Date: 07<sup>th</sup> September 2022  
Our Ref: P1453-1-0010

**Re: Hydrological & Hydrogeological Responses to An Bord Pleanála Further Information Request, and Statutory and Third-Party Submissions, in respect of the proposed Lyrenacarriga Wind Farm, Co. Cork/Co. Waterford (ABP Ref: 309121-21)**

**APPENDIX I: UPDATED Drawing P1453-0-0121-A1-D501-00B**

**APPENDIX II: Drainage Process Flow Diagrams**

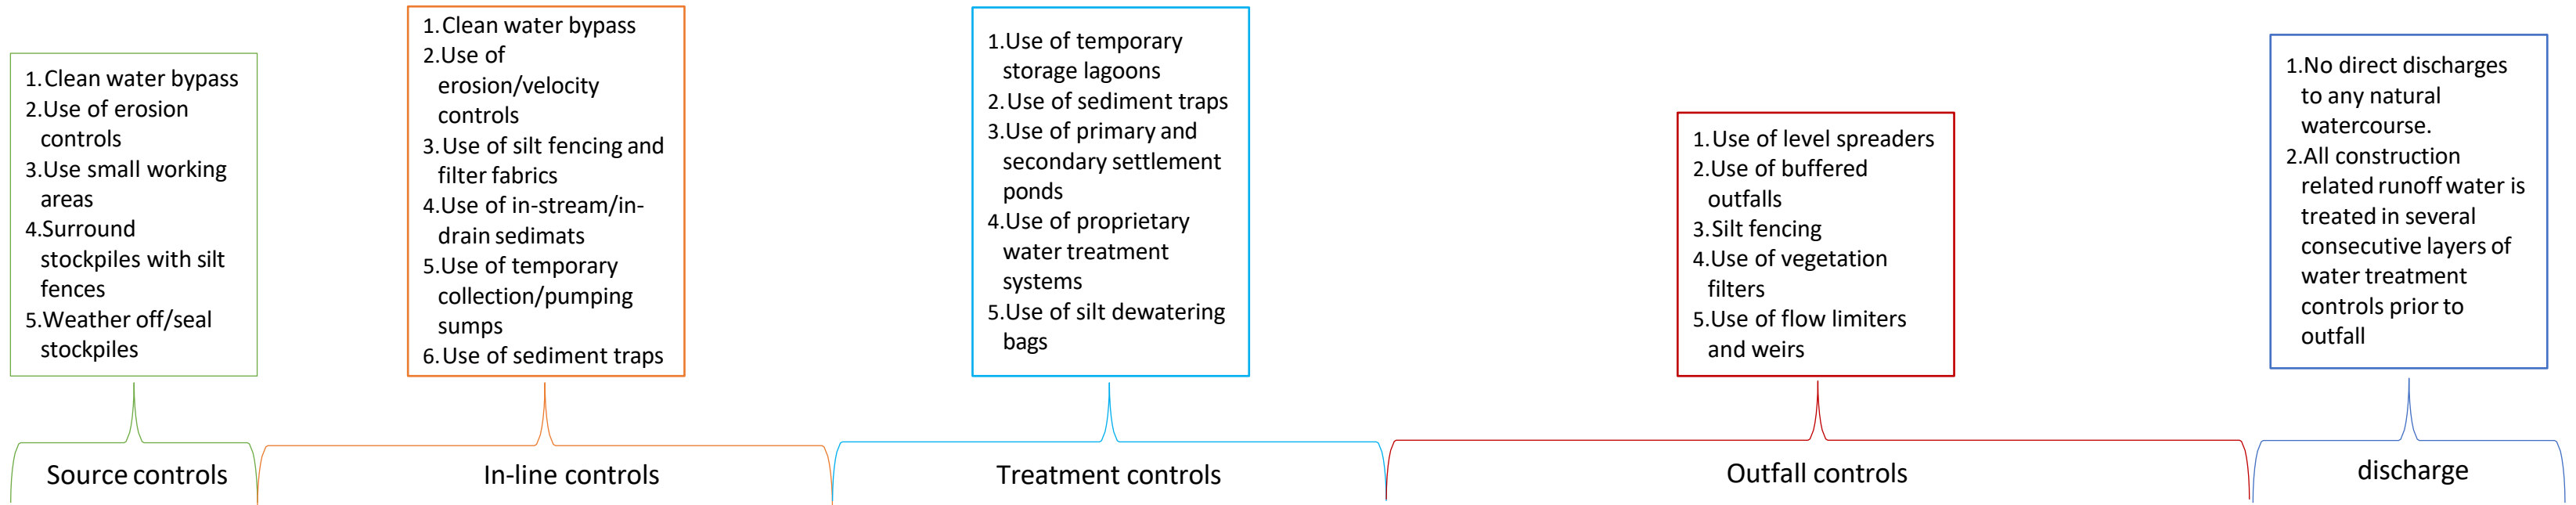
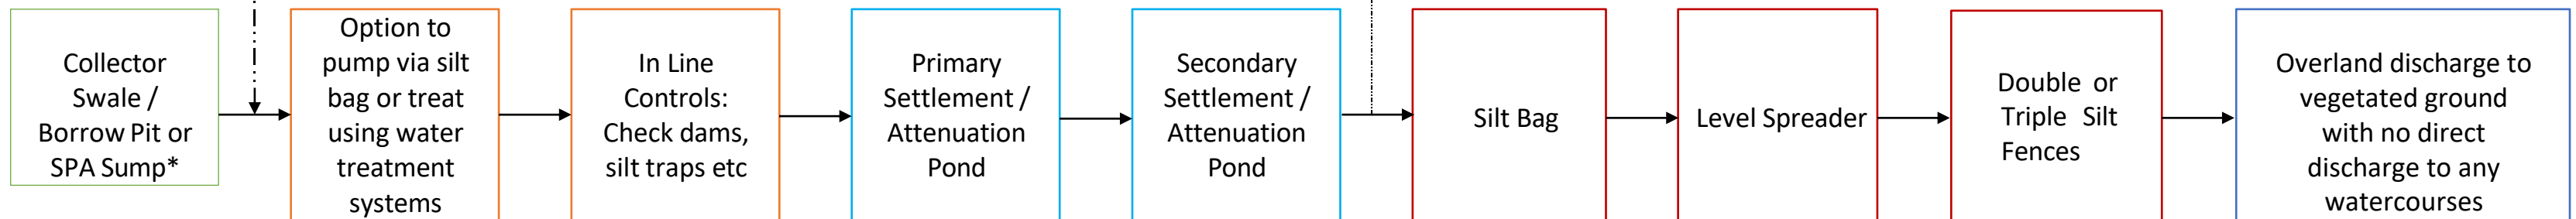
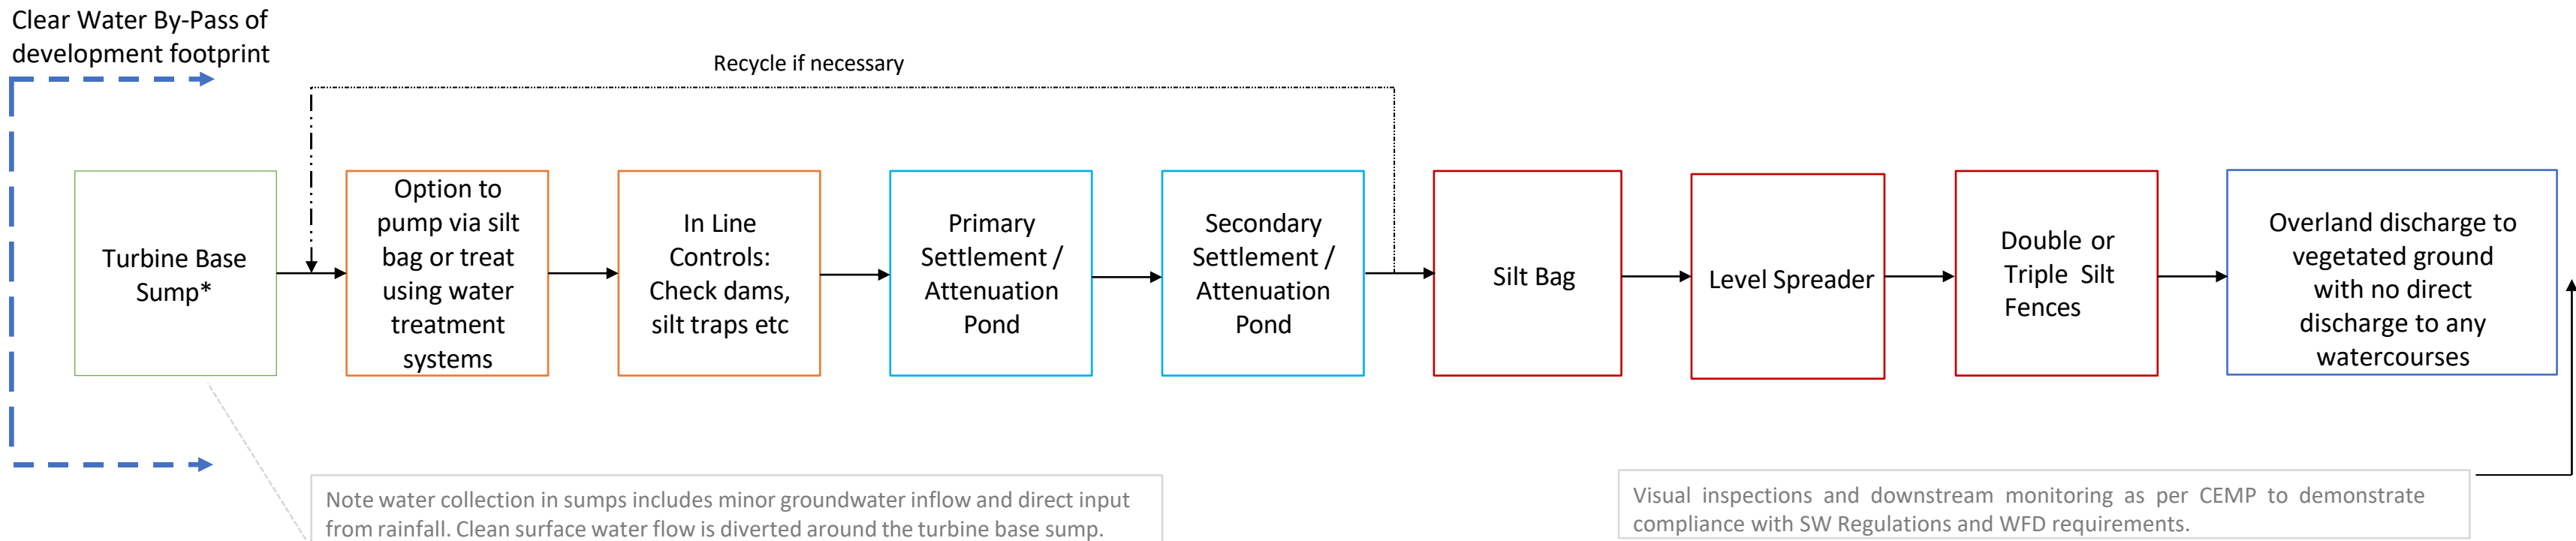
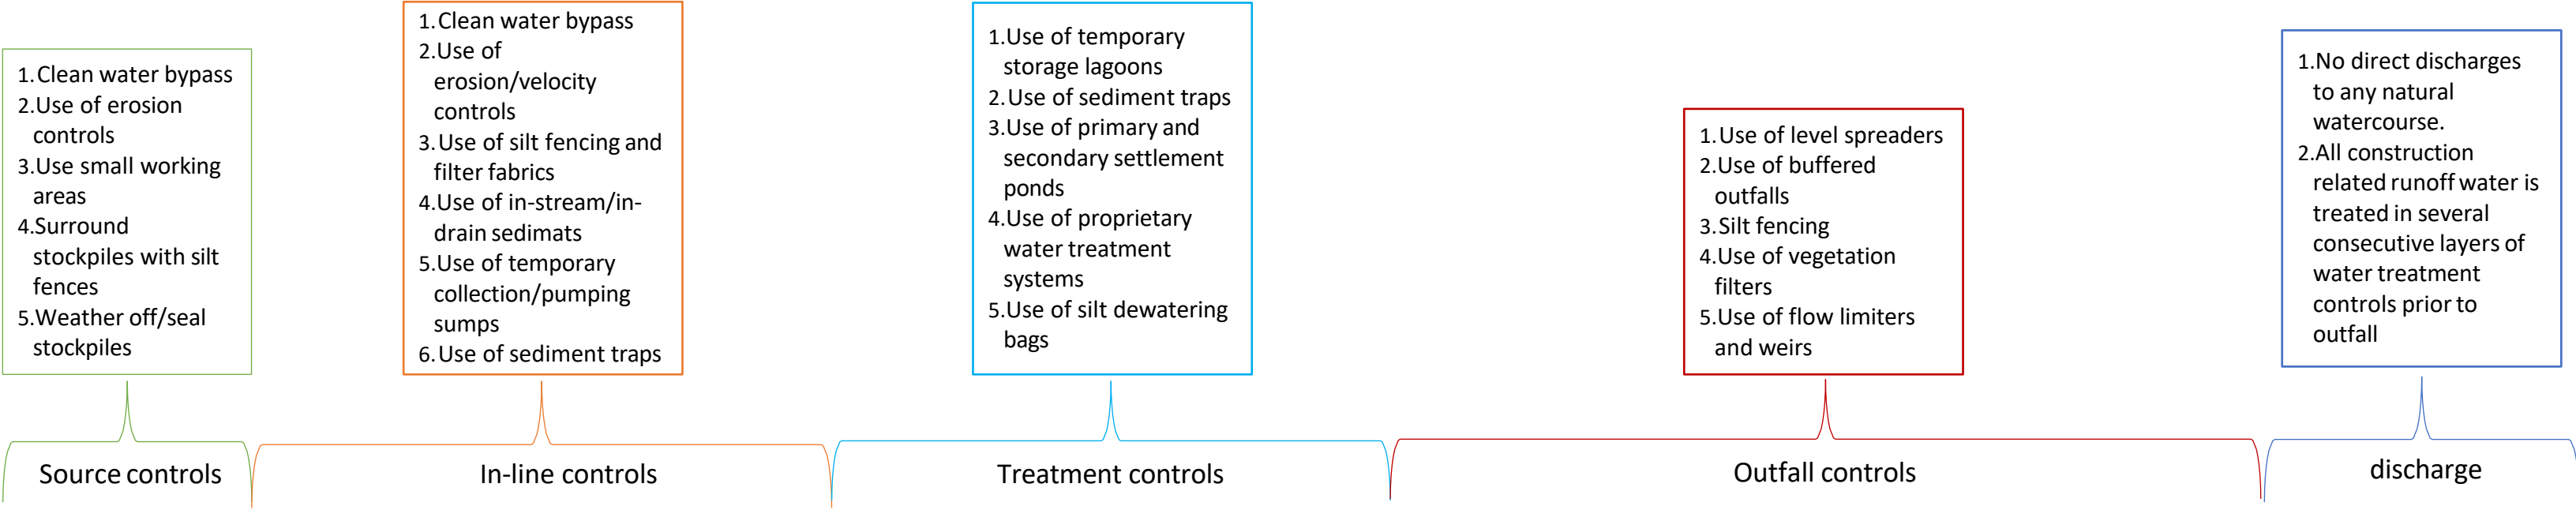
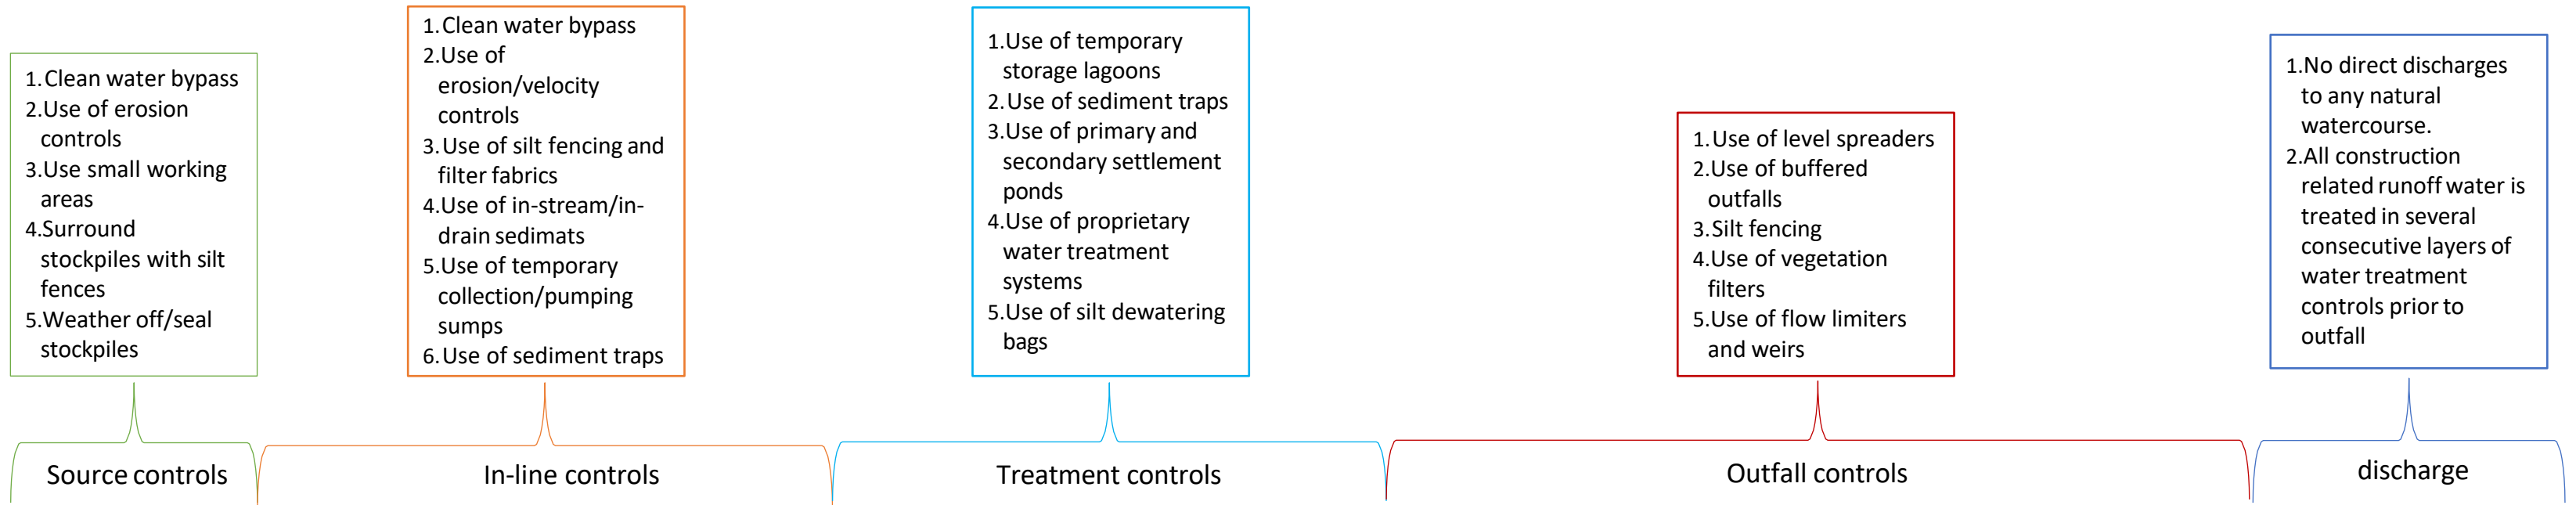
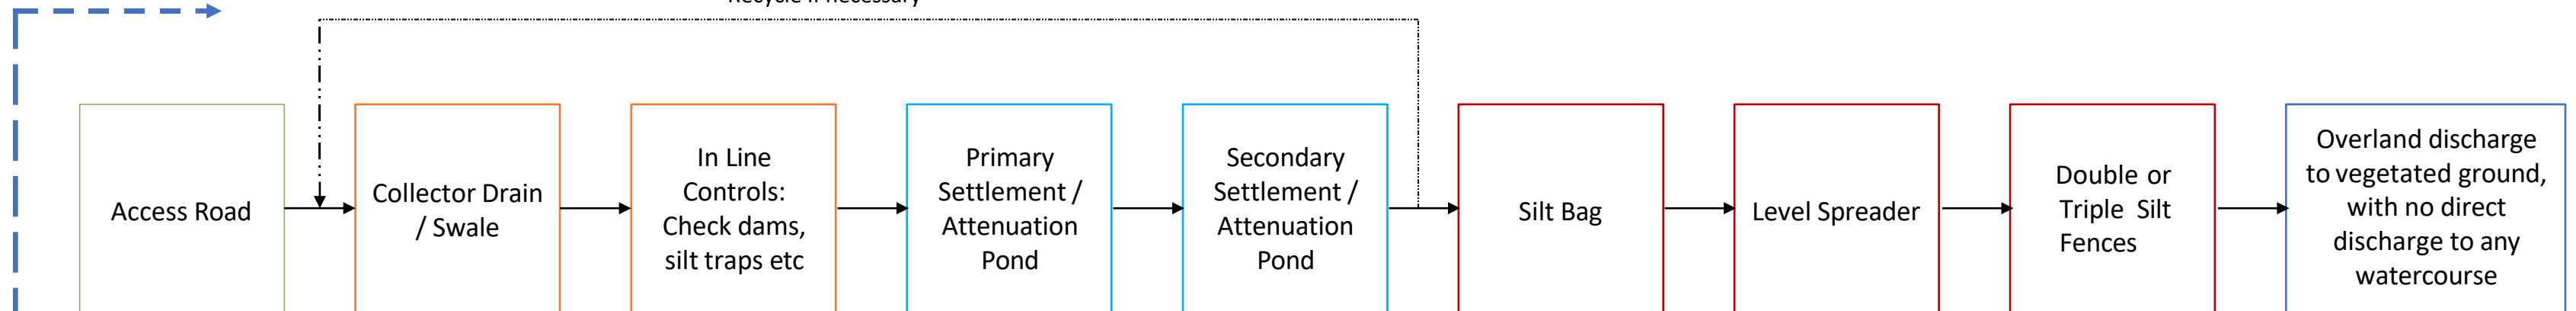
*“Further detail is required in respect of the design detail of the settlement pond structures”.*

- To illustrate this point we have included process flow diagrams showing each element of the proposed drainage systems. These process flow diagrams are attached in **Appendix II.**
